Service data bulletin

Instrument: GDS101

SUBJECT: No depth or unstable depth reading

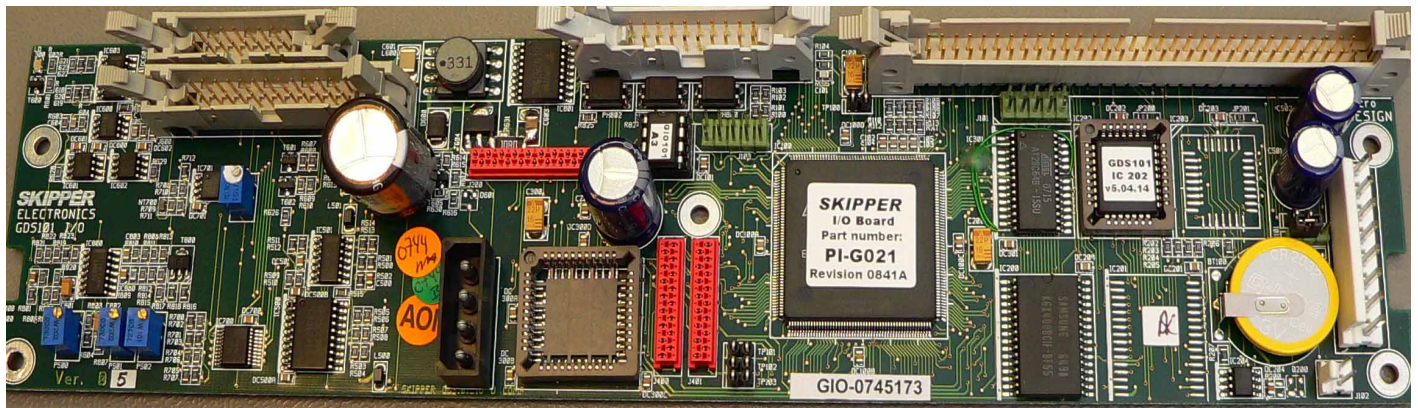
Output power from transceiver is regulated on the I/O board.
On defective boards XCVR (Screen 9) is unstable or too low.

With 100% power XCVR on screen 9 should be stable about 38-46V.
(50% power 19-24V)

Power reduction circuit before rev 0841A

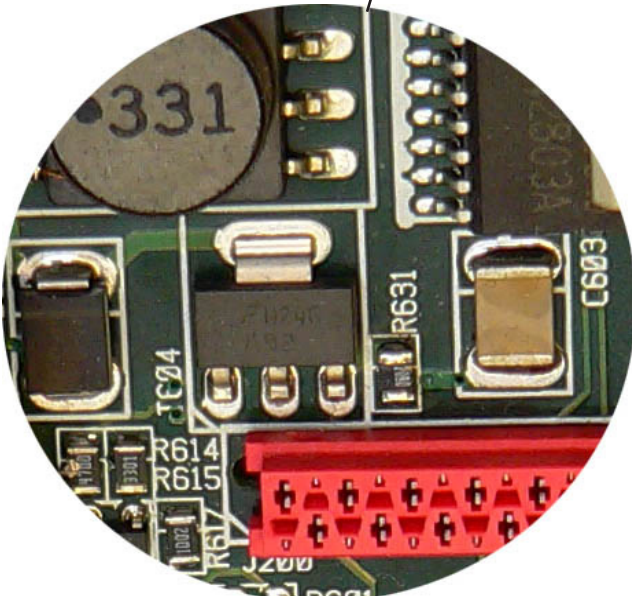
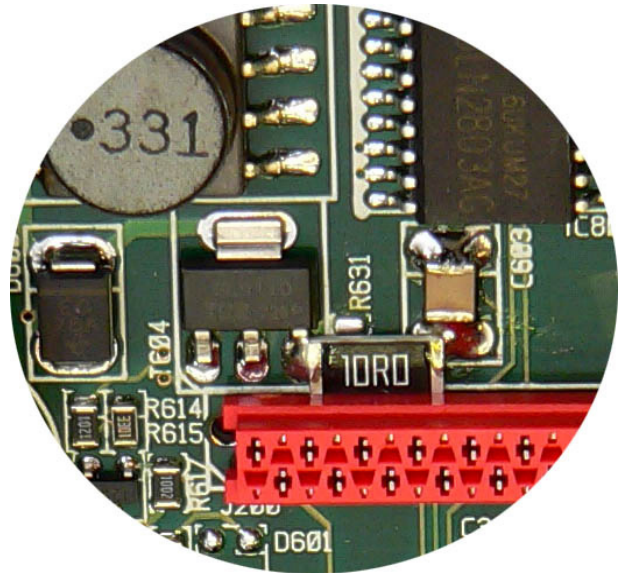
We have analysed return cards and found that in some cases the power reduction circuit fails. This is due to some components being overstressed in this mode.

All I/O PCB from version 0841A can be recognised by the 1W R631.
(There are more differences so please dont try update in field)

We have now replaced these components with components of higher specification, and tests show that this eliminates the problem.

Power reduction circuit from rev 0841A
